06-384r0 SAS-2 OPEN_REJECT RETRY during zoning changes

To: T10 Technical Committee
From: Rob Elliott, HP (elliott@hp.com)
Date: 21 August 2006
Subject: 06-384r0 SAS-2 OPEN_REJECT RETRY during zoning changes

Figure 1 — ZG change example

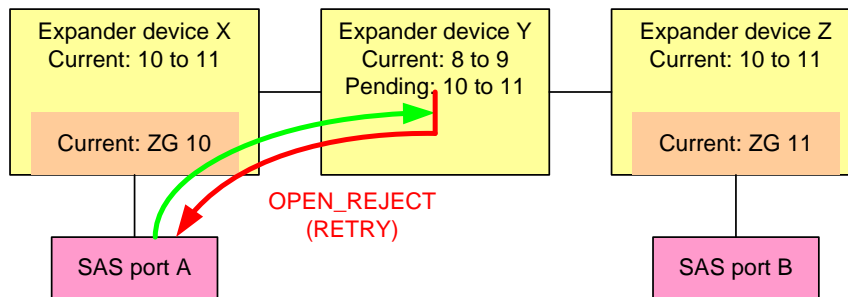
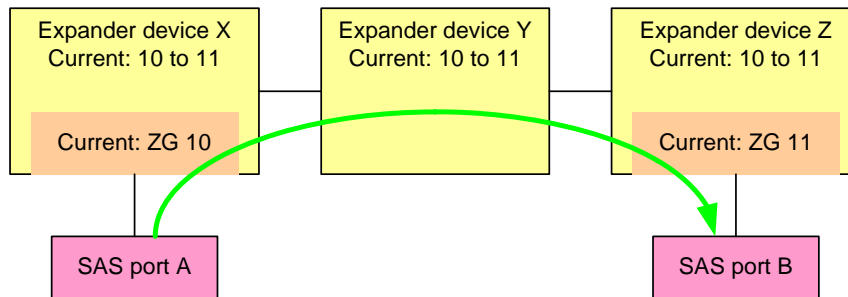
While zoning changes are being activated (per the four-step Lock, Configure, Activate, Unlock process defined in 06-358), the expander devices inside a ZPSDS temporarily but inevitably will have different zone permission table contents. During this time, an expander device that is not activated yet could respond to a connection request with OPEN_REJECT (ZONE VIOLATION) even though the connection request would succeed after that expander device is activated.

For example, assume a phy in zone group 8 has permission to access a phy in zone group 9. The zone manager is reassigning zone group numbers so those phys will change to zone groups 10 and 11. The expander devices that assigns the phys their zone groups is updated (both the zone phy information and the new zone permission table), then one of the phys transmits a connection request. The OPEN address frame is forwarded to another expander that is not yet activated, claiming a source zone group of 10. Since 10 did not have permission to access 11 in the old table, it gets rejected.

Before expander devices X, Y, and Z are activated:

After expander devices X and Z are activated (but Y is not yet):

After expander devices X, Y and Z are activated:

To avoid this, any locked expander device should return OPEN_REJECT (RETRY) rather than OPEN_REJECT (ZONE VIOLATION). A SAS port that receives OPEN_REJECT (RETRY) will try the connection request again (and not even run its I_T nexus loss timer) and not report failure to the application layer. This way, the I/Os will continue to operate during zoning changes.
